MIL-HDBK-1191  
APPENDIX D: UFAS INTERPRETATIONS AND WAIVERS

D.3 DMFO QUESTIONS AND ANSWERS. The Defense Medical Facilities Office prepared a series of questions relative to UFAS and forwarded them to the ATBCB for interpretations. The numbers listed in the Reference column relate to paragraphs and pages in Fed-Std-795, "Uniform Federal Accessibility Standards." Answers to the questions are indicated in **bold** type.

SUBJECT: Waivers and Modifications of Accessibility Standards  
for Psychiatric Ward at Portsmouth Naval Hospital

FIGURE D-3

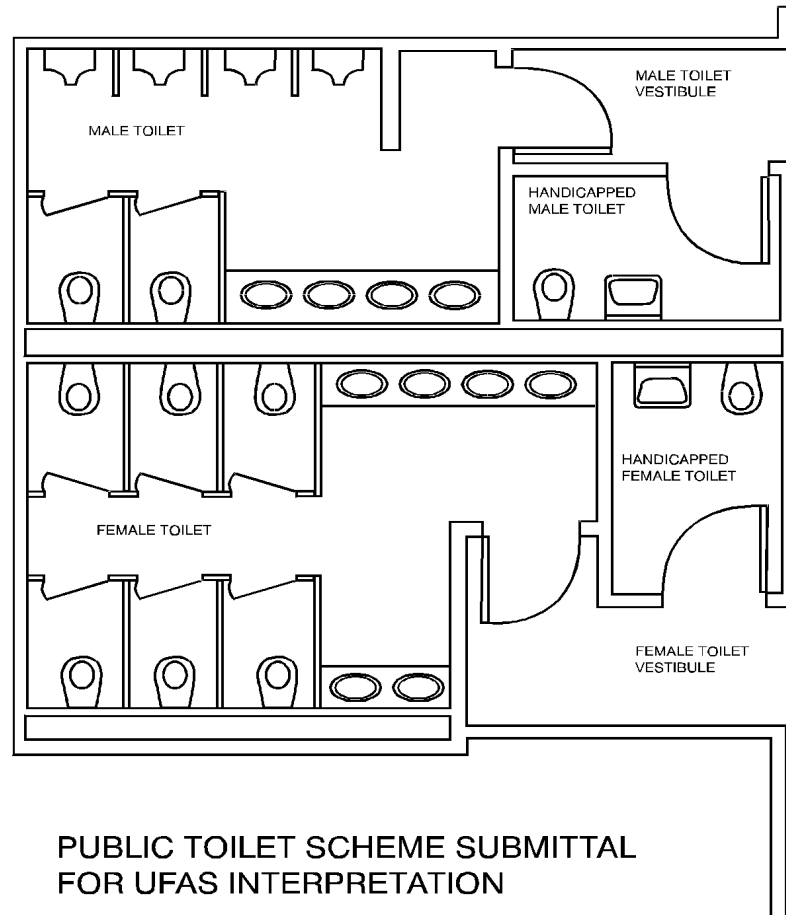
- D.3.3 4.1.4(9)(b),  
p10
- This states that all common use toilet facilities shall be accessible. If an accessible toilet room is placed at the entry to a public toilet, does this satisfy this requirement even though the remainder of the toilet is not accessible? See example plan in Figure D-3.

- The example plan does not meet the requirements for new construction, however, in some alterations the proposed arrangement may be regarded as fulfilling the requirements.**

FIGURE D-5

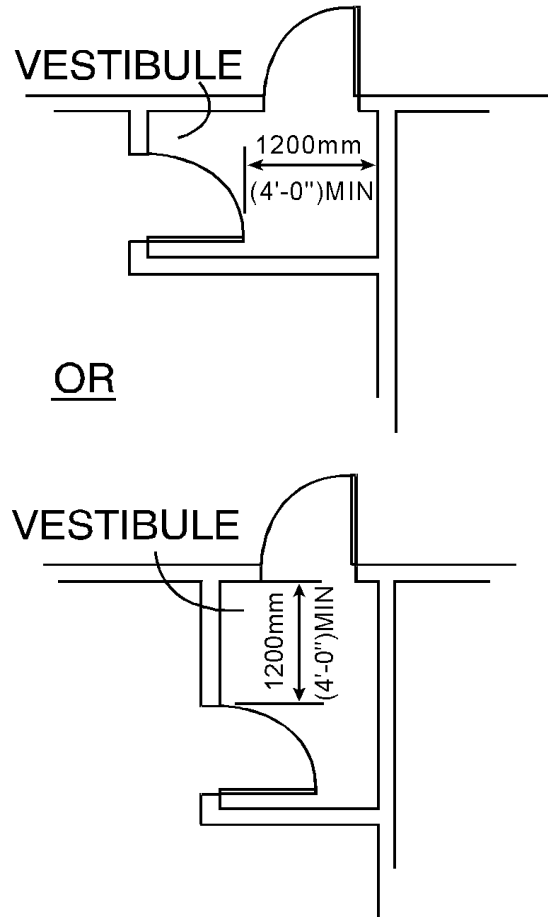
If two doors in series are located in walls perpendicular to each other, is a minimum clear distance of 48 inches required? See example plans in Figure D-5.

**Yes.**

FIGURE D-6

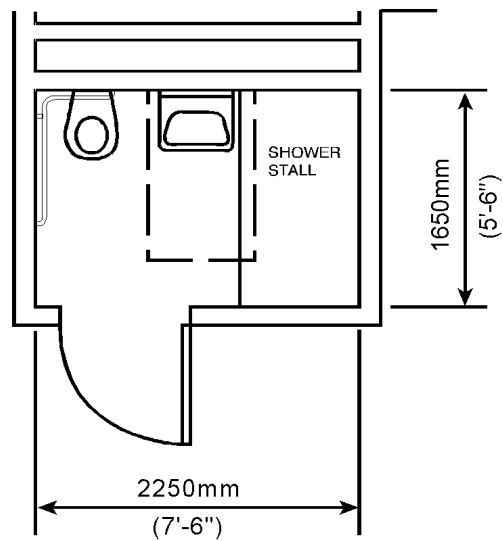
If there is a shower with no curb nor any other obstructions such as shower doors, is it allowable to have a turning space or clear space of another fixture in a single use toilet overlap the shower area? See example in Figure D-6.

NOTE: CLEAR FLOOR SPACE OF SINK OVERLAPS SHOWER  
STALL, WHICH HAS NO CURB

**Figure D-6 does not include the required 36" x 60" clear floor space at the shower. If it did, there would also be sufficient clear floor space for the lav without encroaching on the shower.**

Fig. 31 (b)  
Lavatory Clearances

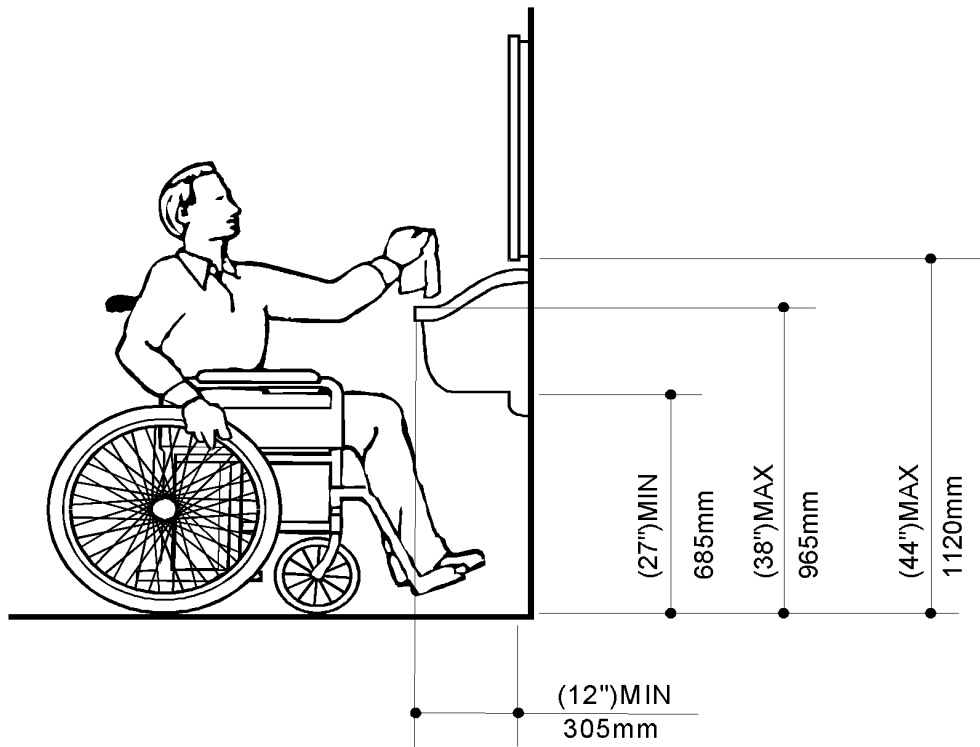
Similarly, because lavatories can be removed from the wall and used as weapons, vandal-proof lavatories are desirable in psychiatric wards. The typical vandal-proof lavatory is 14 inches wide, 12 inches deep, and 10 inches high. The typical accessible lavatory is 20 inches wide, 18 inches high, and 6 inches high. Accordingly, the following modification of § 4.19.2(M) is authorized for the psychiatric ward at Portsmouth Naval Hospital:

4.19.2(M) Height and Clearances. Vandal-proof (prison-style) lavatories shall be mounted so that 50 percent comply with Figure 31(b) and 50 percent with Figure 31(c).

The lavatories in Figure 31(b) shall be mounted with rim or counter surface no higher than 38 inches (965 mm) above the finished floor. Provide a minimum knee clearance of 27 inches (685 mm) below the lavatory. The lavatory shall project a minimum of 12 inches (305 mm) from the wall.

§ 4.19.6 Mirrors. When lavatories are mounted as shown in Figure 31(b), mirrors shall be mounted with the bottom edge of the reflecting surface no higher than 40 inches (1015 mm) from the floor.
